January 26, 2022

**SUBJECT: Constantine Hydroelectric Project (FERC No. 10661)
Response to Final License Application Additional Information
Requests**

Attachment B – Revised Shoreline Stability Assessment Study Report

Attachment D – Revised Exhibit G Drawings

EXHIBIT G-2 SHEET 2 OF 2

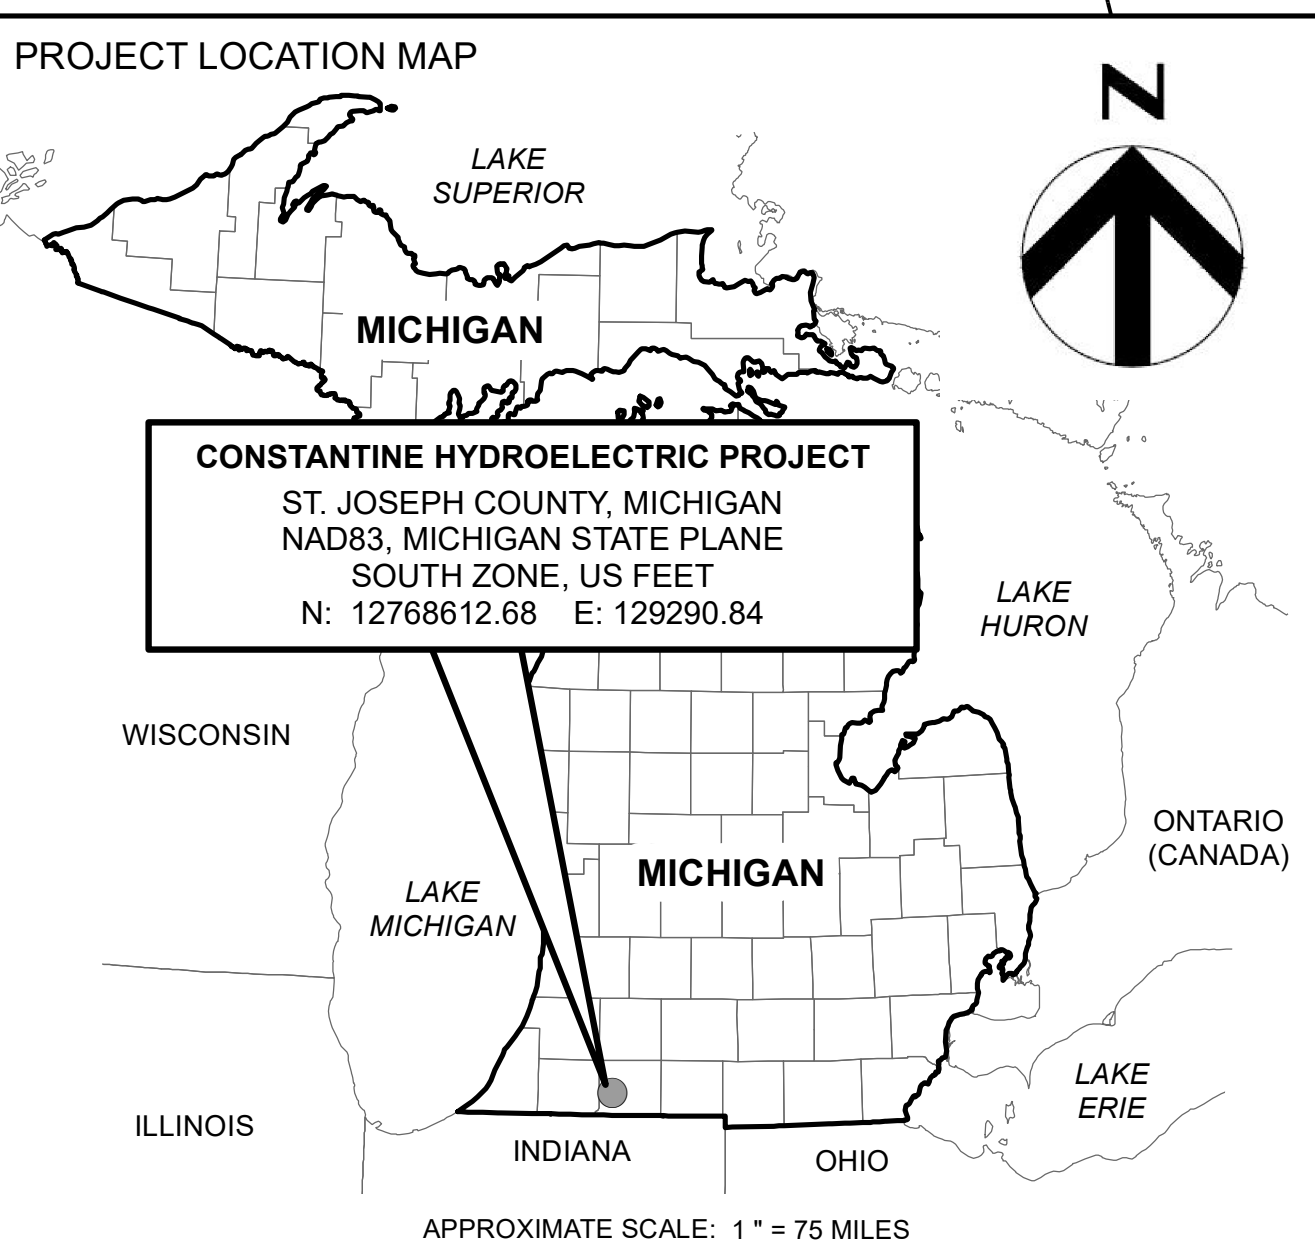
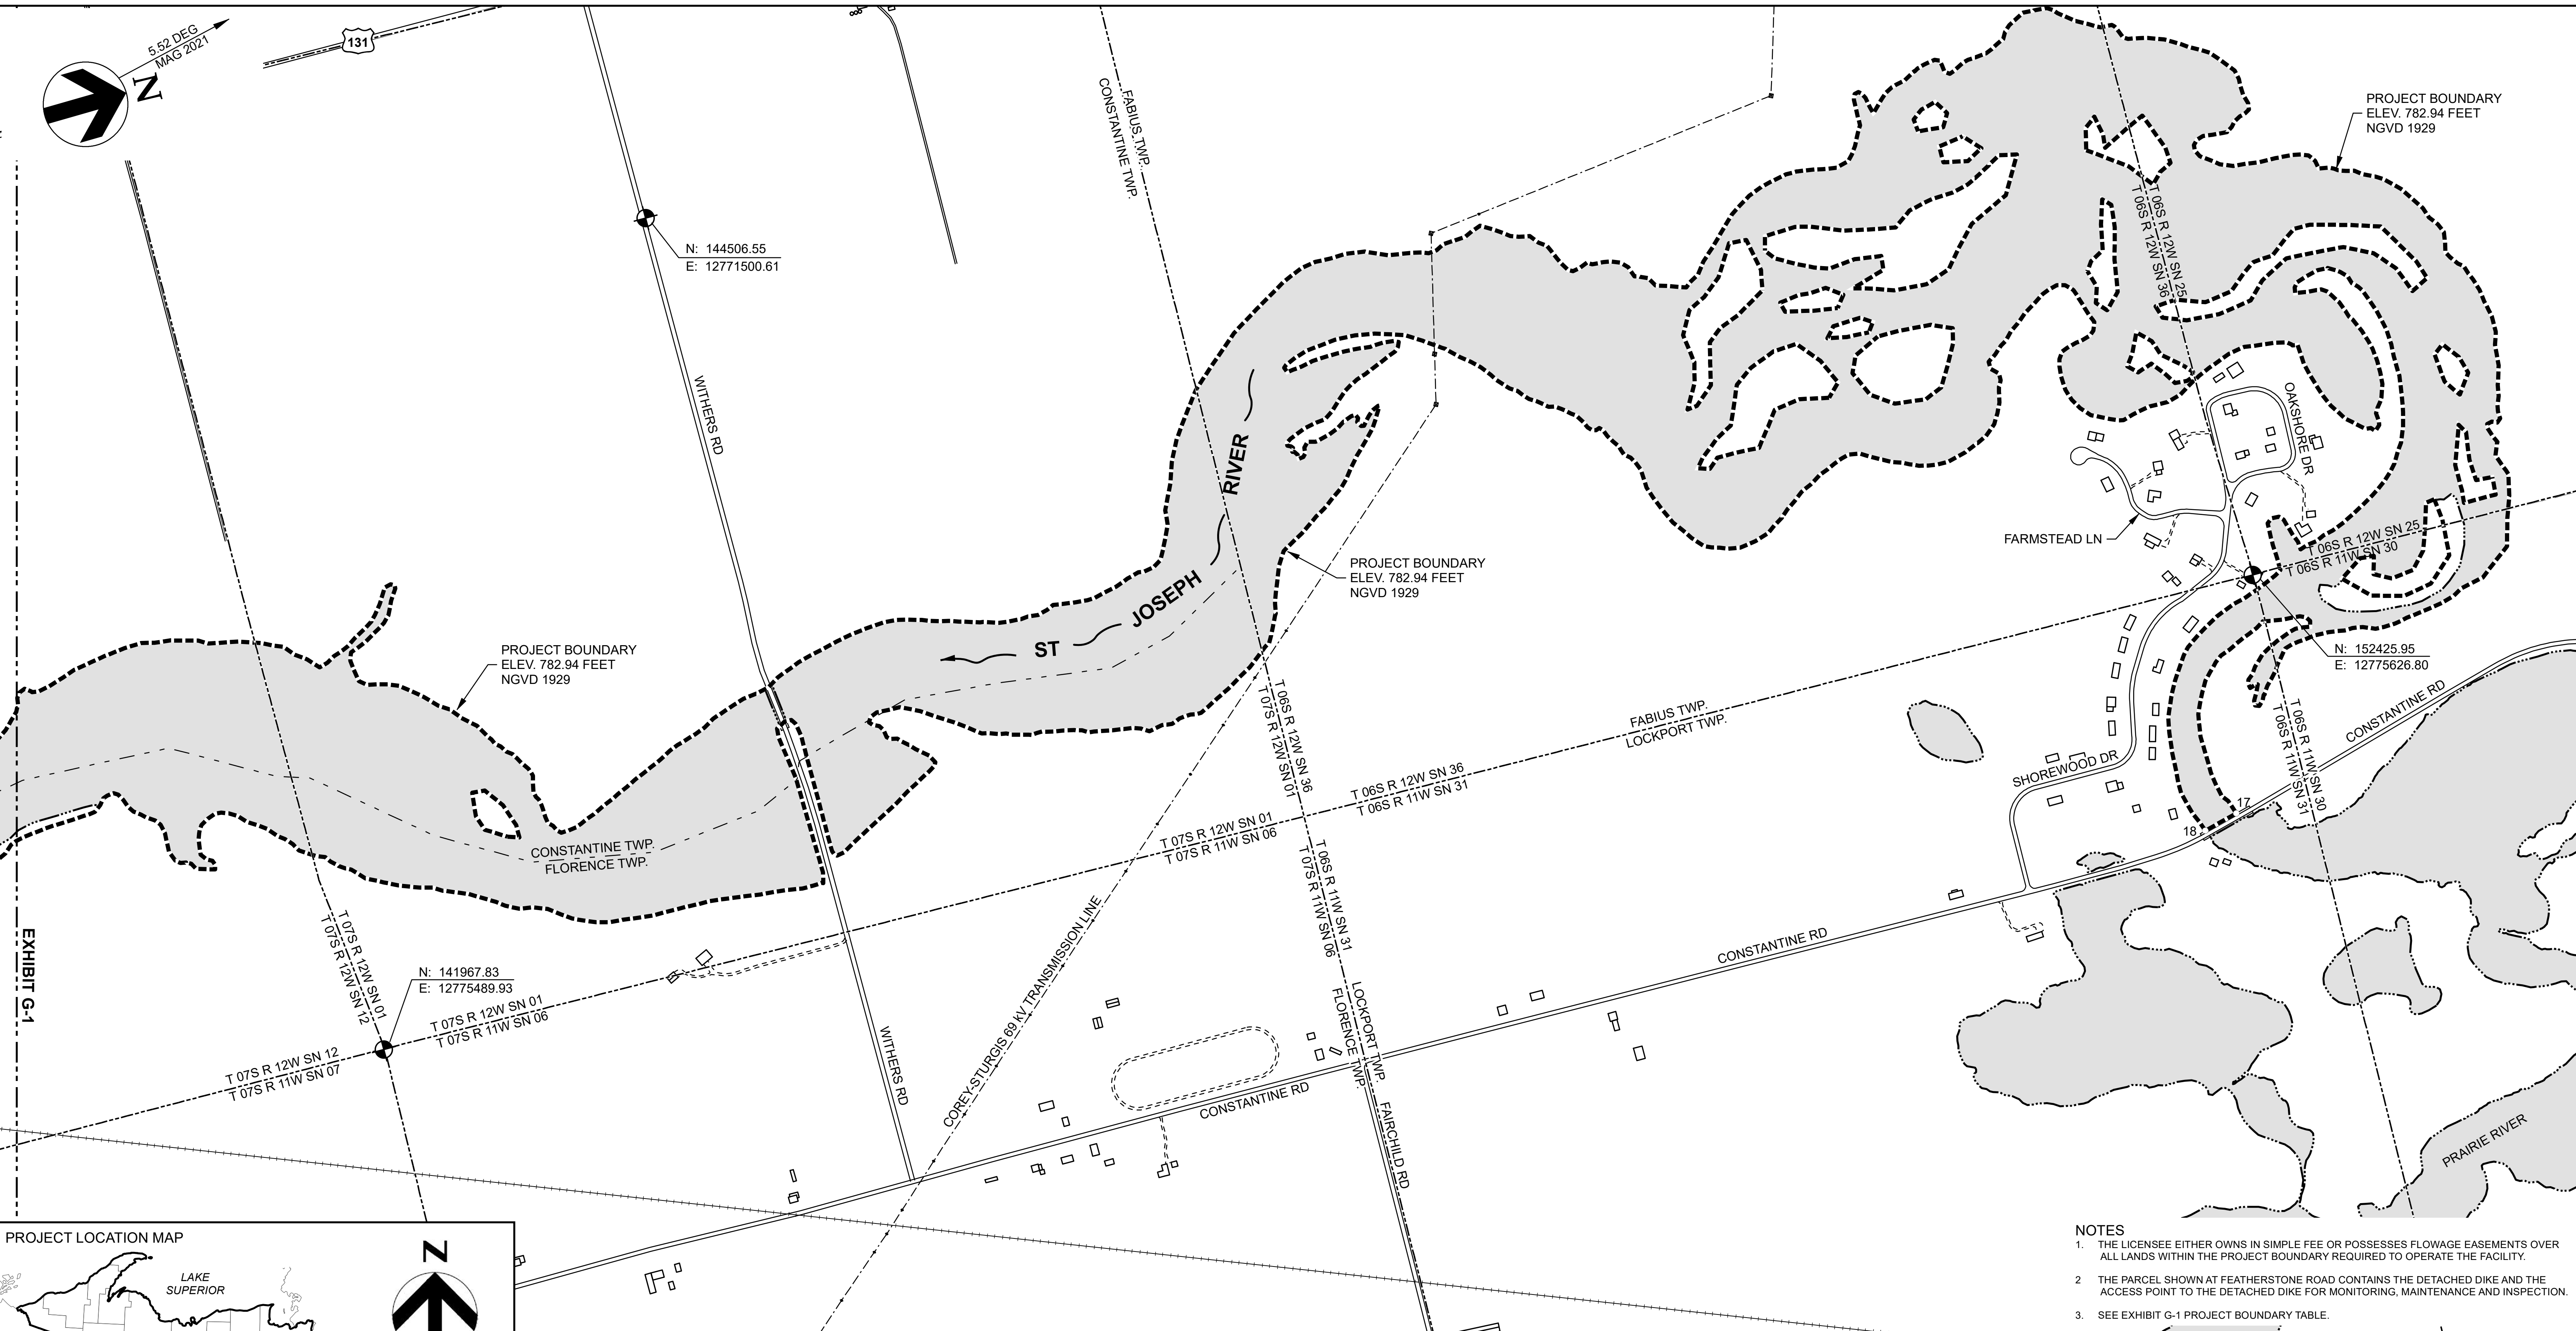
Section 5.18(a)(5)(i) of the Commission's regulations, which references section 4.61 [see section 4.41(h)] requires, in part, that an application show the relative locations and physical interrelationships of the principal project works and other features described under paragraph (b) of this section (Exhibit A) that complies with section 4.41(h)(1). The project's interconnection with Indiana Michigan Power's electrical grid and portage route are not identified on Exhibit G. Therefore, please revise the Exhibit G drawings to clearly identify and label the project's interconnection with Indiana Michigan Power's electrical grid and portage route.

Exhibit G shows the project boundary crossing a corner of the Constantine Project tailwater fishing access parking area, excluding most of the parking area from the project boundary. Please clarify if the tailwater fishing access parking area is within or outside of the project boundary and modify Exhibit G accordingly.

I&M has revised the Exhibit G drawings to label the interconnection with Indiana Michigan Power's electrical grid and portage route. The revised drawings are included in Attachment D of this filing.

I&M has revised the Exhibit G drawing to include the tailwater fishing access parking area.

The parcel shown at Featherstone Road contains the detached dike and the access point to the detached dike for monitoring, maintenance and inspection. I&M has revised the Exhibit G drawing to denote access to the dike.
